Newtown Creek Community Advisory Group (CAG)

November 11, 2024

Re: Proposed Early Action Plan for East Branch Tributary of Newtown Creek

Figure 1. Total PAH (34) in Sediment and Native Material (Figure A2-7a of FFS) with area of core sample gaps highlighted in red.

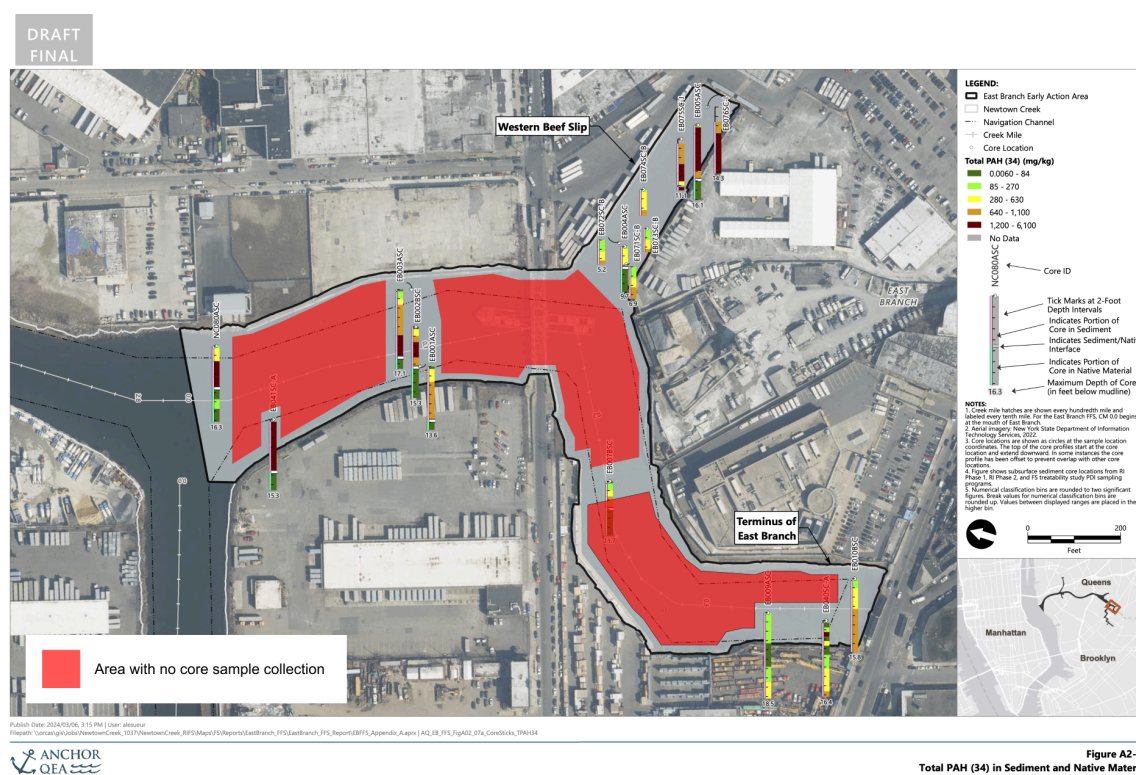
As indicated in Table 1, the maximum number of core samples collected for any one Contaminant of Concern (COC) is 17, which is grossly inadequate for the 11 acres of East Branch. Furthermore, as illustrated in Figure 1, while Total PAH (34) has 17 core samples, the collection of these samples does not follow a geospatial pattern. This has resulted in many areas of East Branch lacking any core samples altogether.

The lack of data in the Proposed Plan further stresses the need for a robust, comprehensive, and systemic Pre-Design Investigation plan (PDI). The CAG requests a PDI that is completed by an independent party overseen by the EPA, and presented to the Community Advisory Group and community at large for comments.
